Cradle Mountain Master Plan Land Use Planning, Environmental, Traffic and Services Review

Cumulus Studio

13 January 2016

Rev 02

Figure 1: Special Area Plan

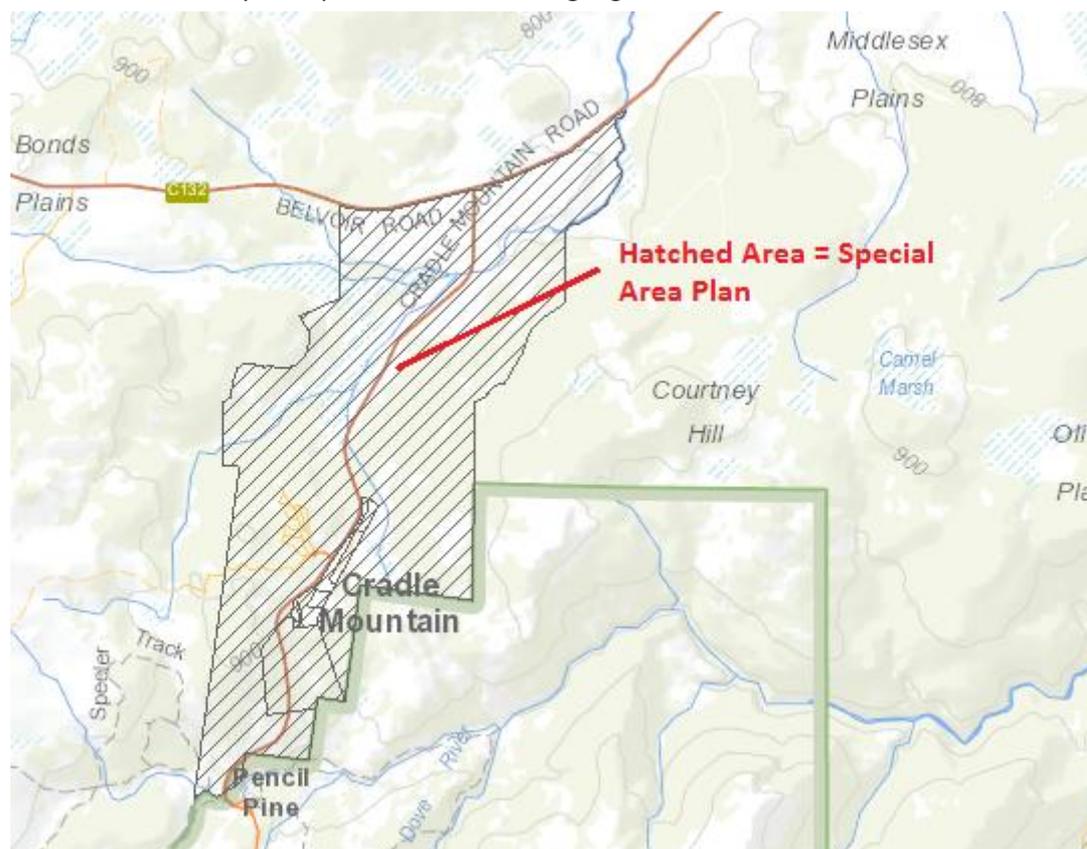
The Visitor Services Precinct is internally divided into Use Nodes as indicated on the planning scheme map as land to which Clause F1.4 applies – the proposal will have to be assessed against the provisions of these use Nodes depending on the location of the final development. Consultation with Kentish Council and potentially the Tasmanian Planning Commission would be required to confirm whether development outside of the nodes can be accommodated.

The area covered by the Special Area Plan is highlighted below:
